Amendments to the Drawings:

REMARKS

Serial No. 09/944,233
Filed August 30, 2001
Attorney Docket No. 3161.3US
Sheet 2 of 15
Contact: K. Weber Powell
(801) 532-1922

Fig. 5

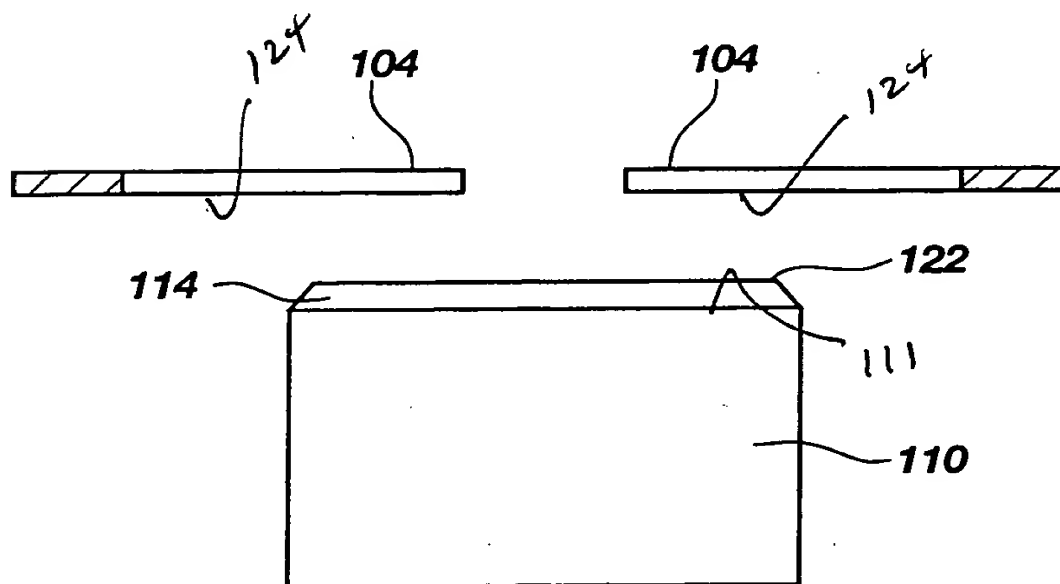
Specifically, FIG. 5 has been revised to add the reference numerals --124-- (two occurrences) and --111-- with appropriate lead lines; FIG. 6 has been revised to add the reference numerals --124-- (two occurrences) and --111-- with appropriate lead lines; and FIG. 7 has been revised to add the reference numeral --111-- with appropriate lead line. No new matter has been added.
